### FY 20 Spalling Concrete Repair 20-PW-255

#### **Addendum No. 1**

Please see questions received regarding this project with answers below:

DRAWING NO.: **LS-6R**

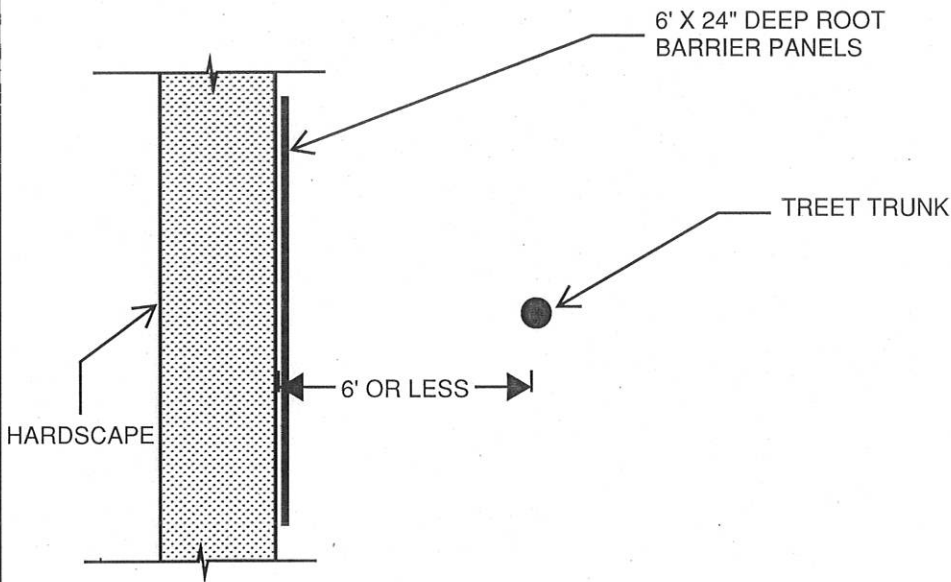
5. Specification pages 200-203 reference root barriers. There is no specification as to when they will be required. Depth, type, quantity, etc.
  - a. **Root barrier shall be installed per the attached Revised City Standard Plan Drawing No. LS-6R. Linear root barrier shall be used in all situations where the hardscape is 6 feet or closer to the tree trunk. Root barrier shall be a minimum 24" deep. See Attachment on next page.**

1. LINEAR ROOT BARRIER TO BE USED IN ALL SITUATIONS WHERE HARDSCAPE IS 6' OR CLOSER TO TRUNK OF TREE
